Quible & Associates, P.C.

March 27, 2024

Re: Major Site Plan Application Resubmittal
Athletic Facility – 1559 Waterlily Rd
Coinjock, Currituck County, North Carolina

A copy of the TRC review comments dated March 12, 2024 (McAdams) and March 13, 2024, are enclosed for reference, and our responses listed below for ease of review:

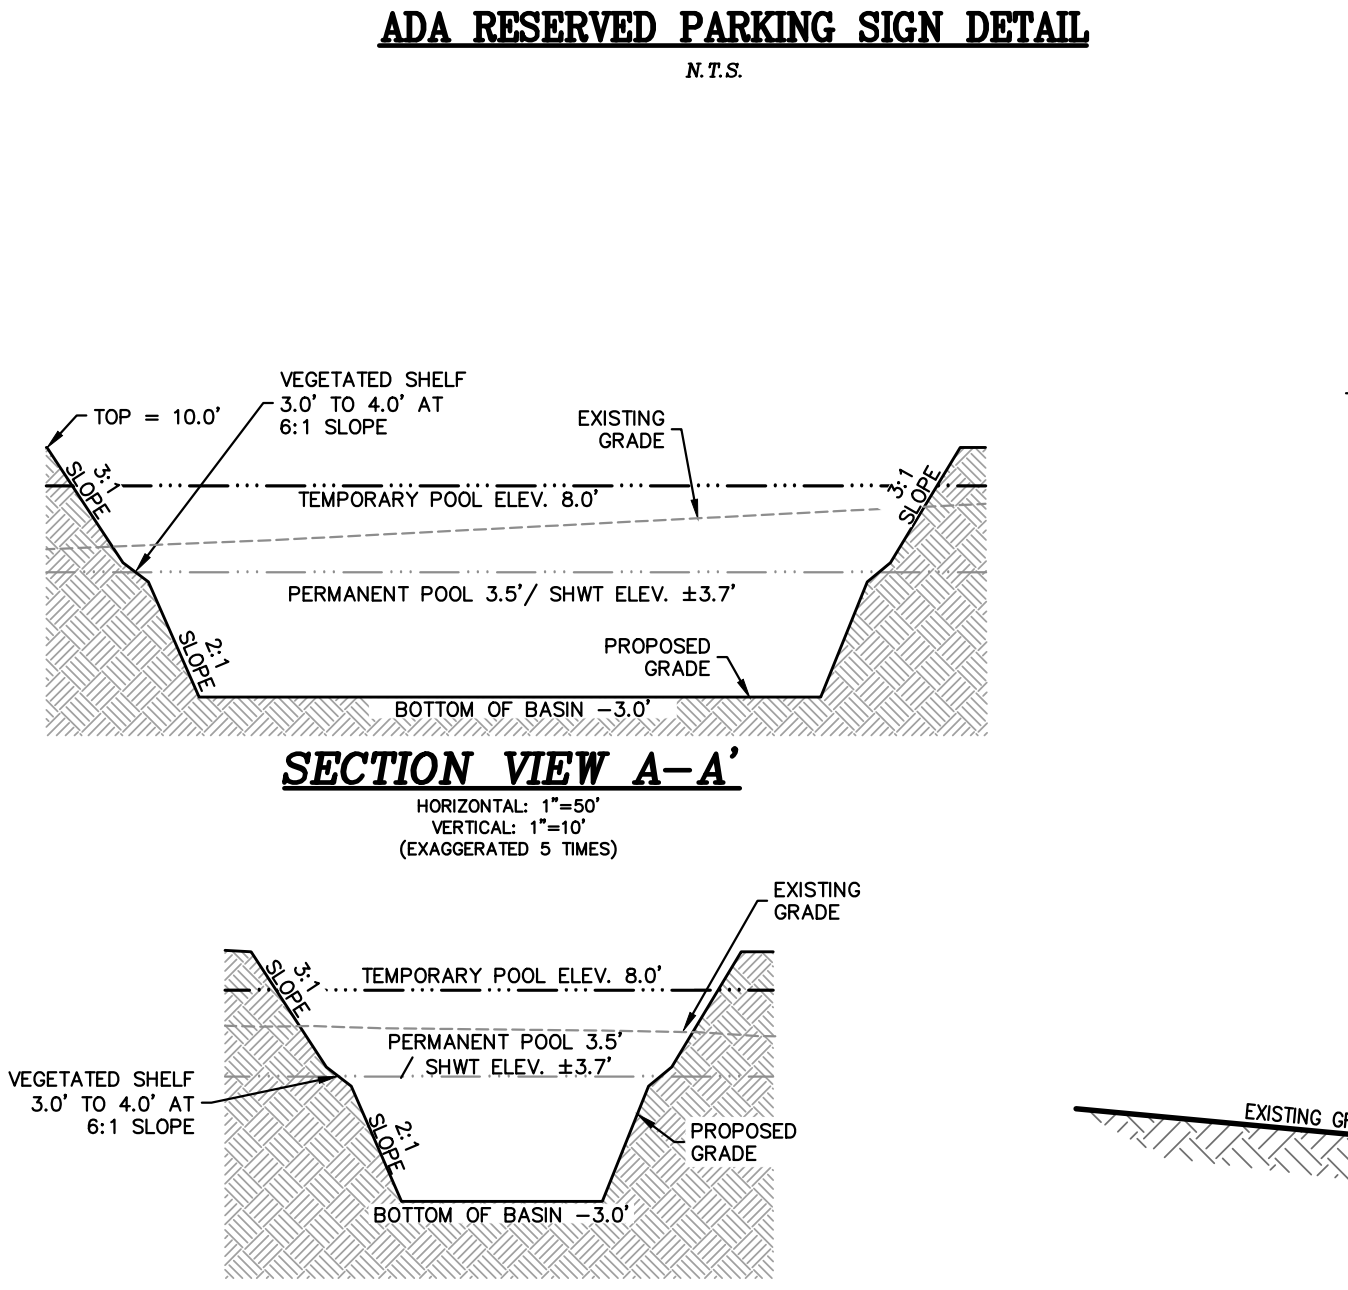
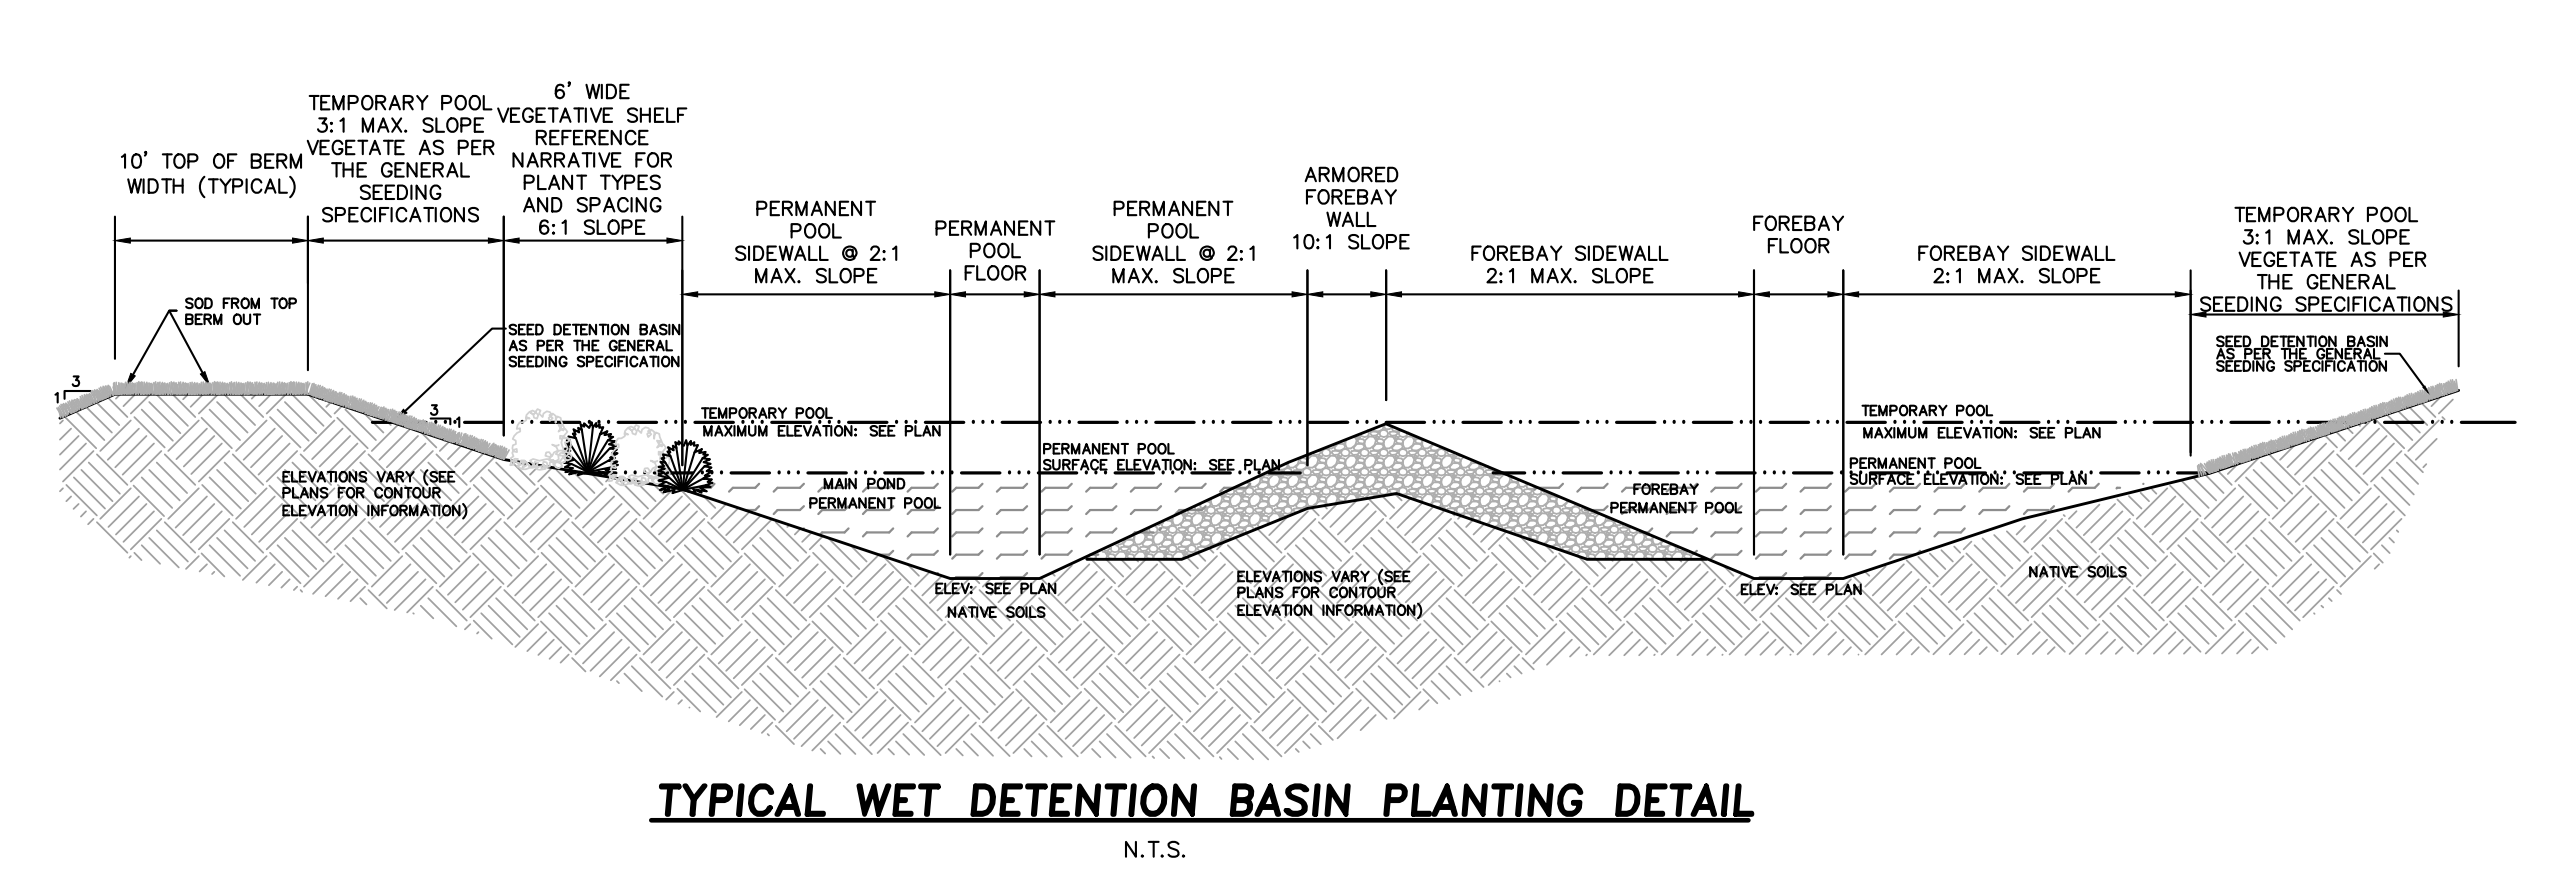
6. SESC Sheet #6 – Callouts for the wet pond detail do not match those in the plan view on Sheet #5. Correct slope call out to more accurately reflect the proposed design. *Acknowledged. This detail has been updated.*

7. SESC Sheet #6 – Callout downstream invert elevation of pipe network to the wet pond forebay. *Acknowledged. This invert has been updated.*
8. SESC Sheet #6 – Outlet structure detail call outs don't match those listed on the plan view, specifically pipe invert elevation and size. *Acknowledged. The inverts in plan view have been updated to match the outlet structure detail and a downstream swale is now shown.*

9. SESC Sheet#6 – SHWT and Permanent Pool Elevation are defined as 3.5' in this detail. SHWT is defined as 3.7' throughout the rest of the report. These values should match for
